**RE:** **P.Z. 04-2019 13559 Olive Blvd (McDonald's)**: A request for a zoning map amendment from a "C8" Planned Commercial District to a "PC" Planned Commercial District for a .86 tract of land located north of Olive Blvd., west of its intersection with North Woods Mill Rd. (16Q241471)

## Planning Commission Staff Report

**Petition:** **P.Z. 04-2019 13559 Olive Blvd (McDonald's)**: A request for a zoning map amendment from a "C8" Planned Commercial District to a "PC" Planned Commercial District for a .86 tract of land located north of Olive Blvd., west of its intersection with North Woods Mill Rd. (16Q241471)

Figure 4: Existing and Proposed Conditions

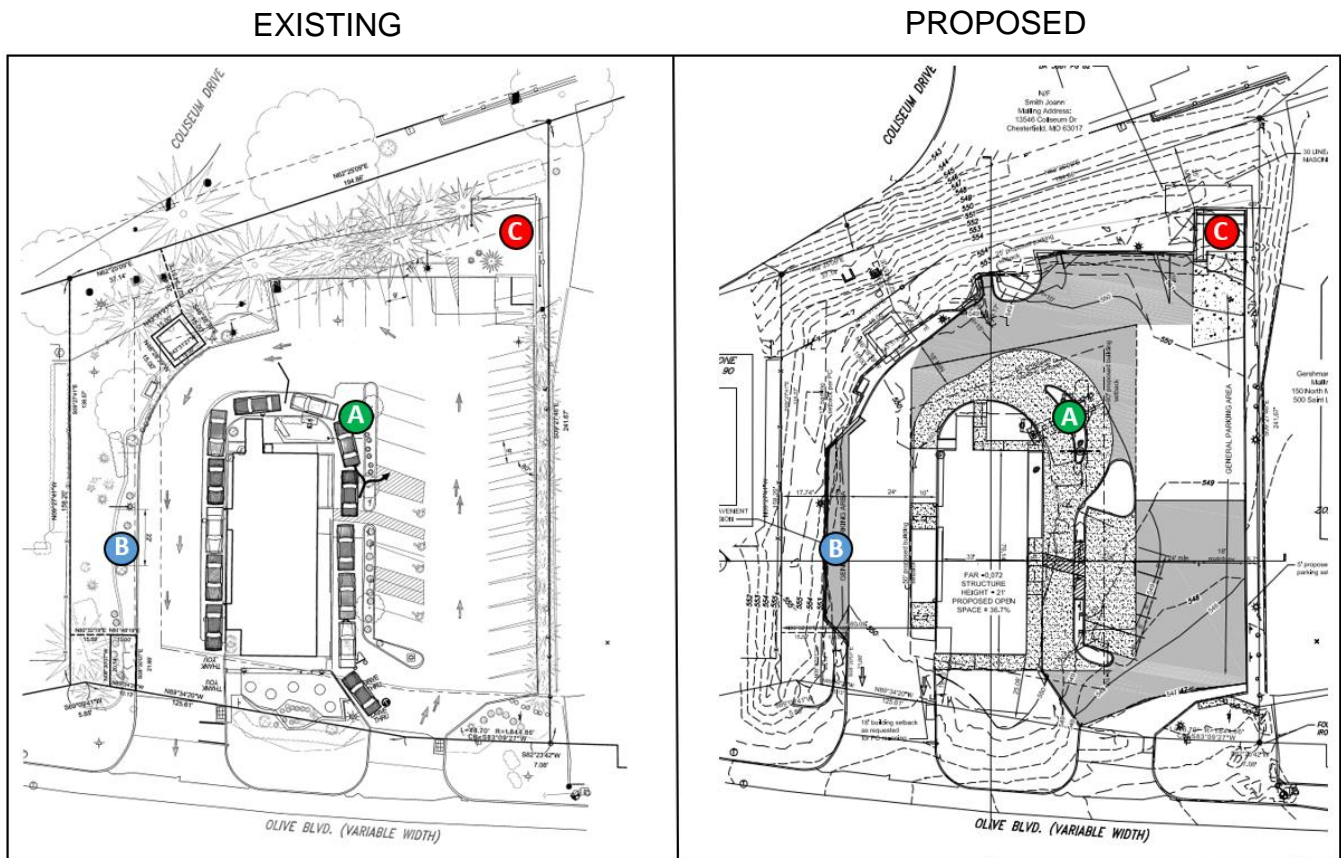
The site has two curb cuts along Olive Blvd., one as a dedicated entrance, and one as a dedicated exit. Olive Blvd. is classified as a major arterial roadway in accordance to the City's street classification map and owned and operated by the Missouri Department of Transportation (MoDOT). In accordance to 2016 MoDOT traffic counts, there are just over 36,000 average annual daily travelers on this section of Olive Blvd. Below, Figure 4 depicts both the existing conditions represented on a plan and the proposed Preliminary Development Plan (PDP) included in the PC Packet, along with how the vehicles will stack around the drive-thru in both scenarios. The three most prominent differences between the existing and proposed plans would be the addition of the double drive-thru (A), the newly created parking west of the building (B) and the trash enclosure moved to the north (C).

4. **Trash Location-** The Preliminary Development Plan depicts the trash enclosure positioned north from its current location and, as a result, closer to the residential property to the north.
  - Identify how the updated trash location will impact residents to the north.

**Response** – The applicant stated that the trash pick-up is 6 days a week (Sunday excluded). The new location of the trash enclosure will necessitate the existing screening fence be removed. To mitigate the impact of the new location, the applicant is agreeable to re-installing a new denser (non-masonry) screening fence on the north side of the new trash enclosure for an approximate length of 30 feet as depicted on the submitted Preliminary Development Plan.

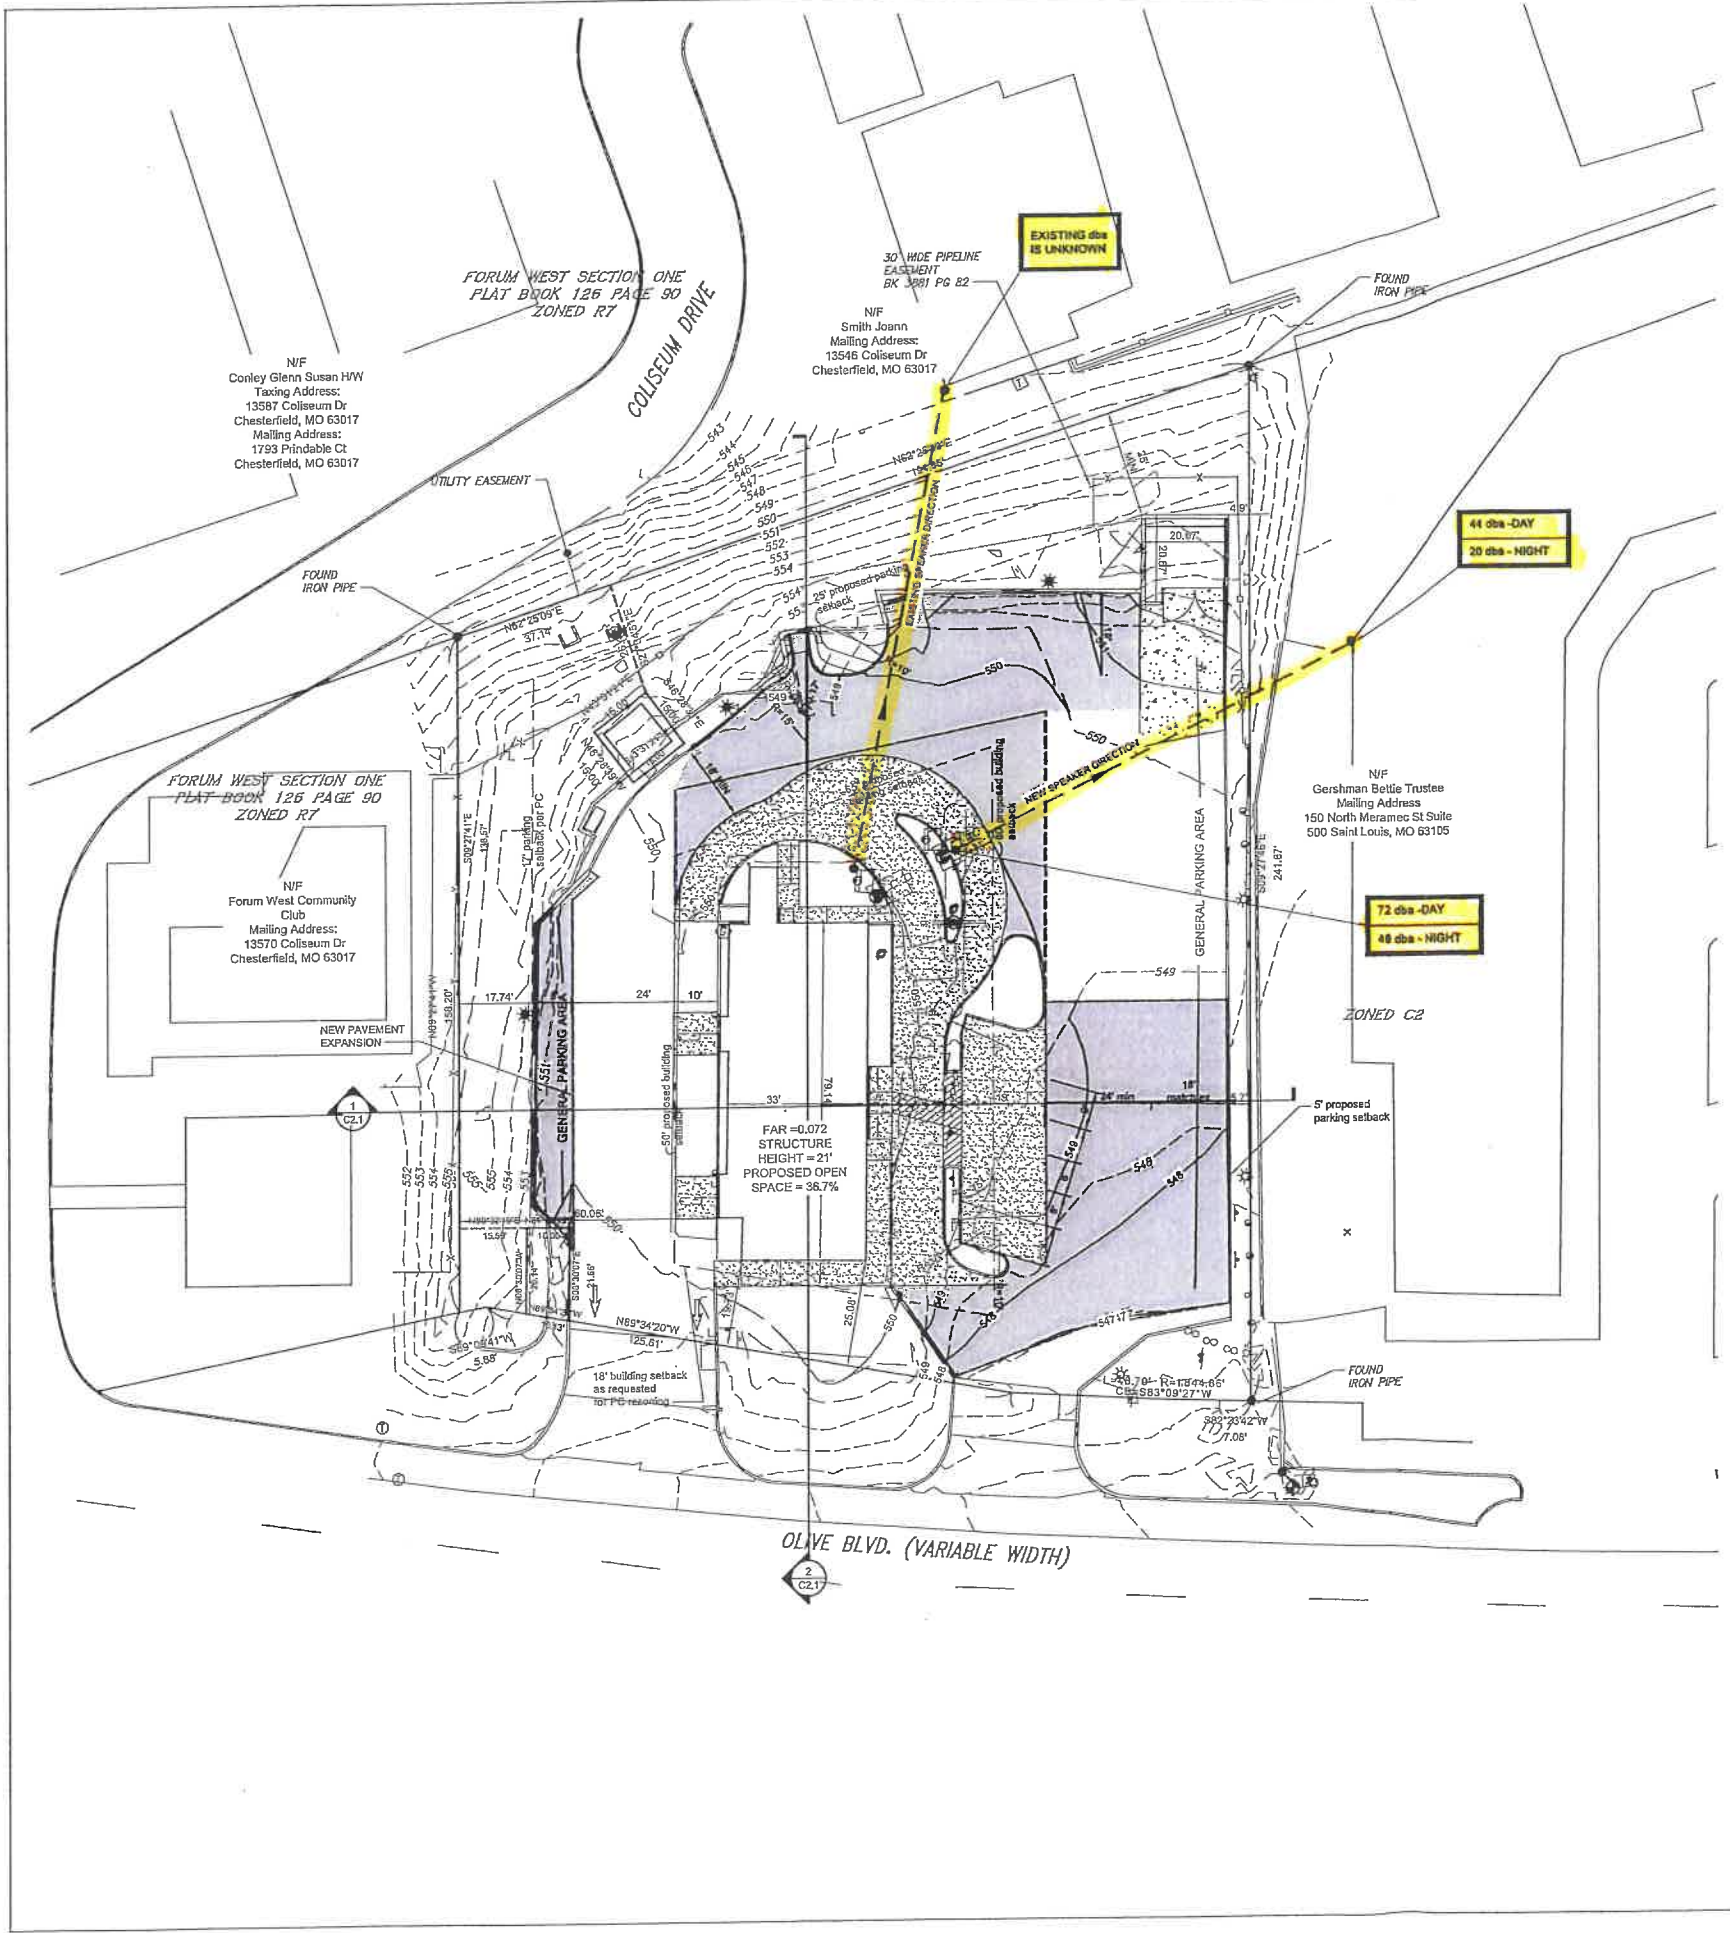
- The construction of a sidewalk along Olive Blvd was an issue raised by the Planning Commission, is a Unified Development Code requirement, and a Comprehensive Plan Policy. Identify the location of this sidewalk on the Preliminary Development Plan.

Regarding a public sidewalk along Olive Blvd, we have communicated with MODOT regarding their conceptual plans for future improvements to Olive Blvd. Their plans do include a new 6 feet wide sidewalk adjoining a new curb on Olive as well as a pavement overlay. The location of the new walk immediately adjoining the back of curb then necessitates the complete reconstruction of both access drives at McDonald's in order to comply with ADA guidelines, as shown on the MODOT plans.

To require our client to construct a new sidewalk adjoining the existing curb on Olive, which would then necessitate the reconstruction of both access drives, is a waste of money and resources. There is no way to ensure that a new walk and access drives constructed today would not then be torn out and replaced by MODOT tomorrow. In fact, assuming the elevation of Olive is modified by MODOT's plans it would not be possible for us to know that difference today, nor would it be possible to accommodate that difference today. MODOT has confirmed their improvements are on the books for 2021. With that in mind we request the requirement for a new public sidewalk adjoining Olive Blvd. not be imposed on this project.

Our client is, though, agreeable to providing a short section of new sidewalk connecting the adjoining east shopping center with the McDonald's parking lot to facilitate pedestrian movement between the two properties. This approximately 25 feet long sidewalk would be located near the south end the existing building on the shopping center and connect to the south end of the McDonald's parking lot.

**TYPICAL SOUND LEVELS**

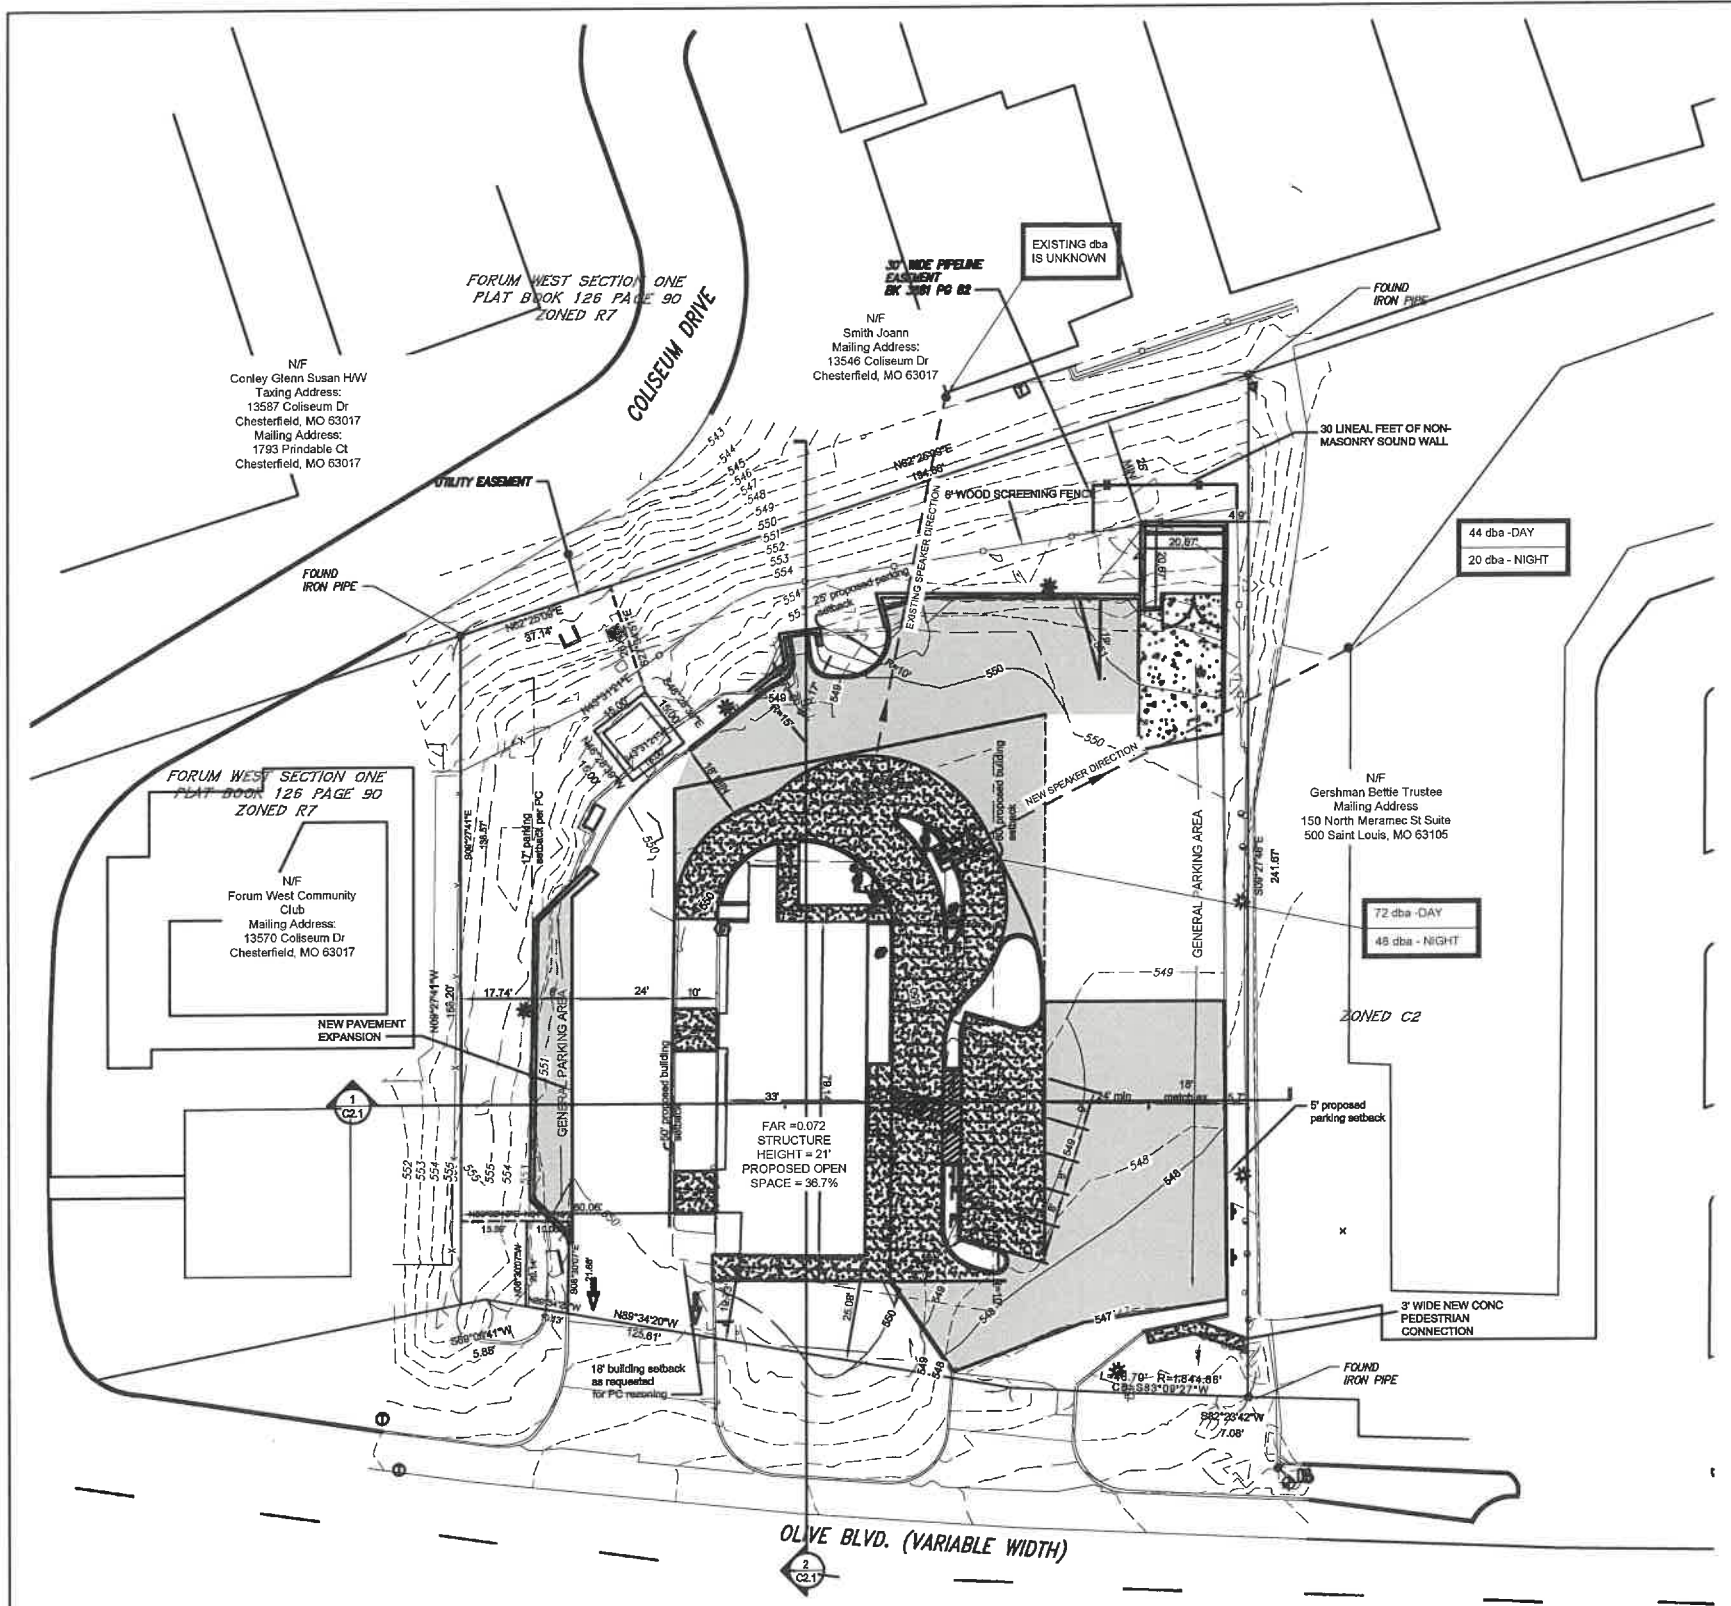
1. **Sound**- Both the Planning Commission and the members of the public identified the concern of noise levels given the proximity to residential neighborhoods.
  - Confirm the sole area on the site projecting outside sound from speakers will be from the double drive-thru ordering station. Given the double drive-thru ordering station is in a new location, describe how this will impact sound traveling through the site and the direct impact on the neighboring residents.
  - The current condition of the perimeter fence is in a less than desirable condition. Address the site's ability to upgrade the fence to a sound wall designed to specifically mitigate noise given the concern of increased hours of noise levels and the addition of the noise (order station) closer to the residents to the north.

**Response** – The applicant stated that the new order station will direct sound in a much more easterly direction towards the adjoining shopping center. The applicant has provided an exhibit depicting the existing and new directions of sound as well as the sound levels. The new speaker system also incorporates automatic volume control which is reduced during the night. The exhibit depicts that there will be no additional noise from the ordering stations on the neighboring residential properties.

THE NEW SPEAKER SYSTEM INCORPORATES AUTOMATIC VOLUME CONTROL (AVC) WHICH ADJUSTS OUTBOUND VOLUME BASED ON THE OUTDOOR AMBIENT NOISE LEVELS. WHEN AMBIENT NOISE LEVELS DECREASE AT NIGHT, THE AVC WILL REDUCE THE OUTBOUND VOLUME ON THE SYSTEM.

Figure 1

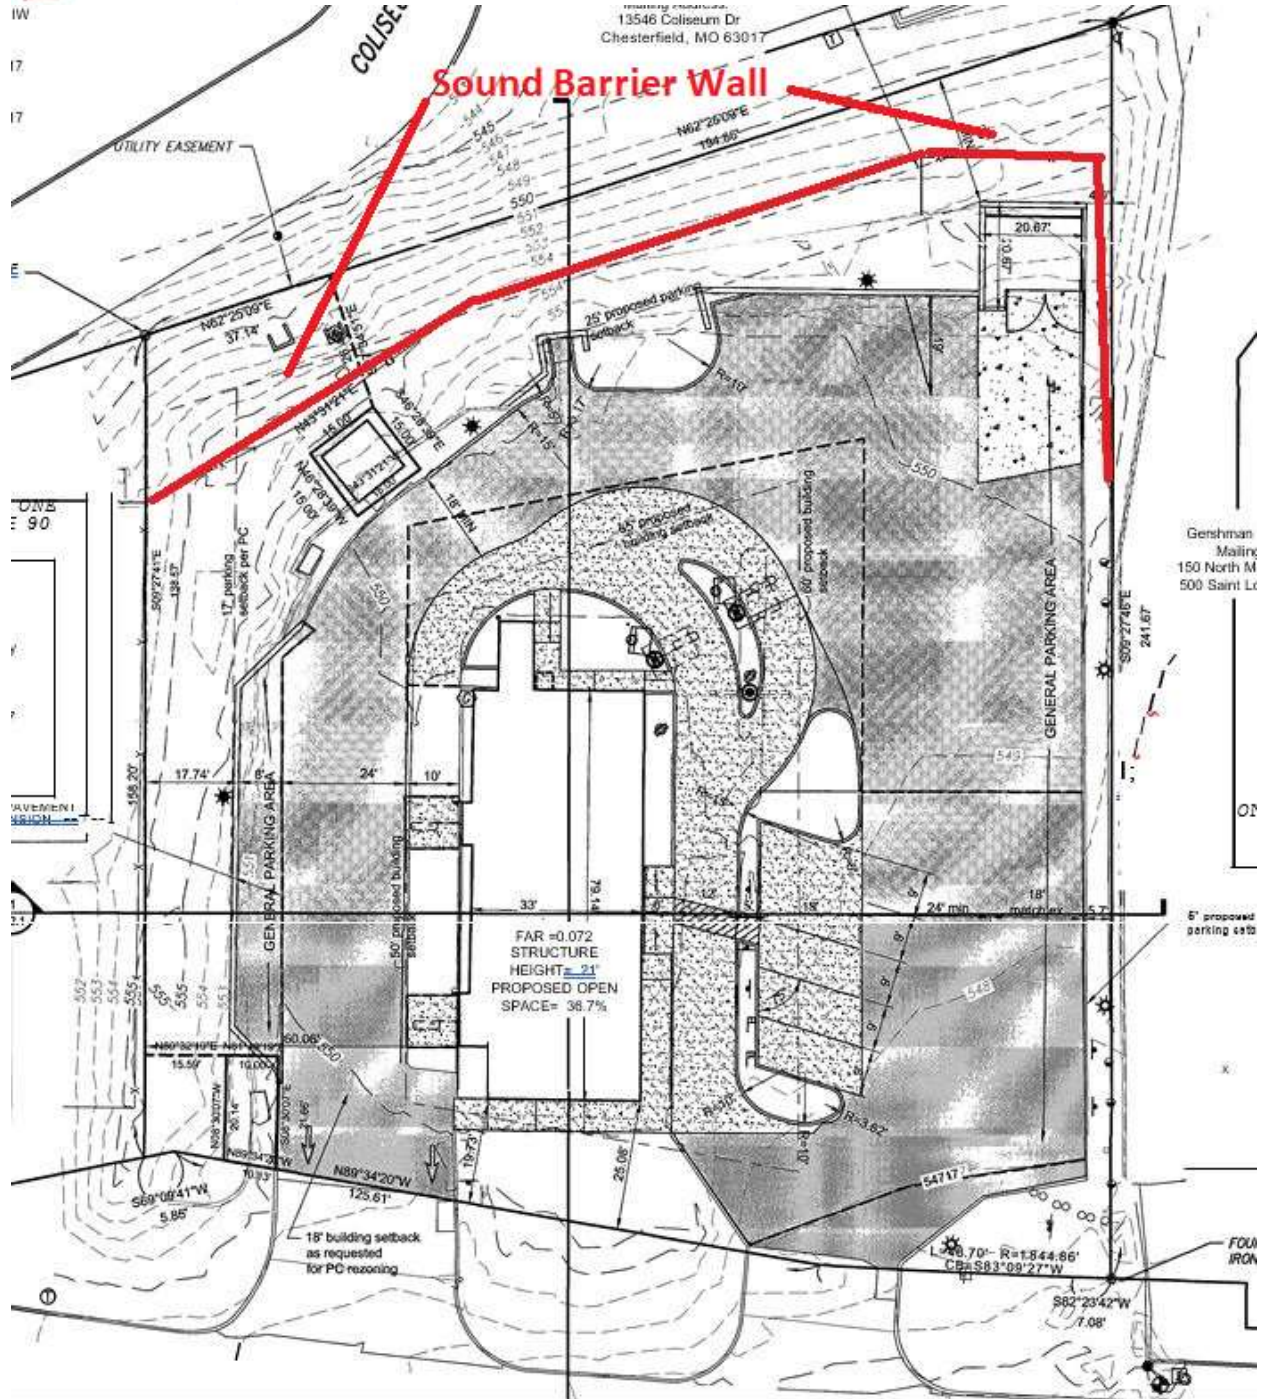
We would ask that parking lot lighting be modified to a shaded style lamp. Below on Exhibit 2 is picture of the current lamps. Exhibit 3 is a better approach with lights focused down rather than out (this picture taken at the Chesterfield McDonalds on Clarkson).
